Office Action Summary	Application No. 10/803,512	Applicant(s) ROME, GUY	
	Examiner QUYNH-NHU H. VU	Art Unit 3763

DETAILED ACTION

Fig. 6 flipped side

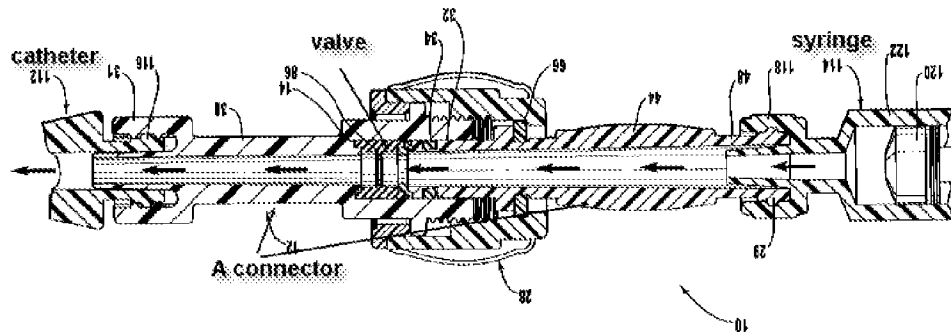
Regarding claims 30 and 44-45, Lampropoulos discloses, in Fig. 6, a catheter assembly, comprising: a catheter 112 including at least one lumen; and a connector (element 38 and 41 formed the connector) including a distal end 31 attached to a proximal end 116 of the catheter and a passageway in fluid communication with the at least one lumen, a proximal portion 29 of the passageway including an engagement feature 29 configured to connect an end of an instrument 114 to the connector, a distal

portion 18 of the passageway including a valve (including elements 80 and 14) longitudinally fixed with respect to the connector, the valve proximal end distal of the engagement feature.

Lampropoulos does not disclose that the valve built-in having a closed proximal end with a slit and an open distal end; wherein the valve proximal end is fixed with res

Fig. 4

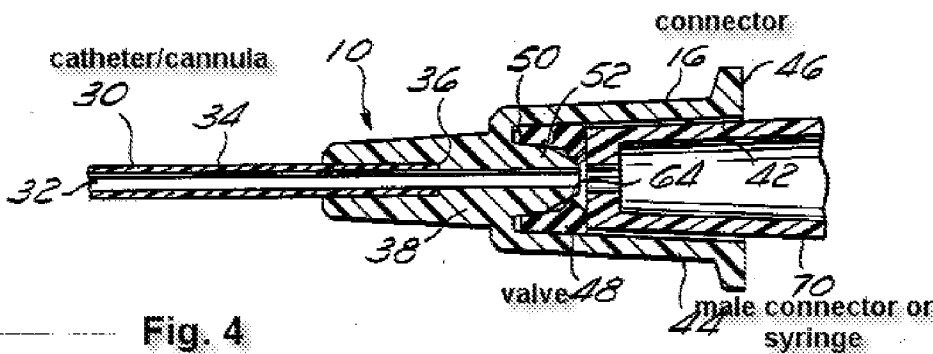
Newgard discloses a catheter assembly comprising: a catheter/cannula 30; a connector 16; a valve 48 longitudinal connected with the connector 16; wherein the valve having a closed proximal end with a slit 64 and open distal end, (see Fig. 3), the valve 48 proximal end distal of the engagement feature 70, see Fig. 4 below.

It would have been obvious at the time the invention was made to a person having ordinary skill in the art to modify the device of Lampropoulos with a slit valve, as taught by Newgard, in order to prevent the fluid back flow therethrough.
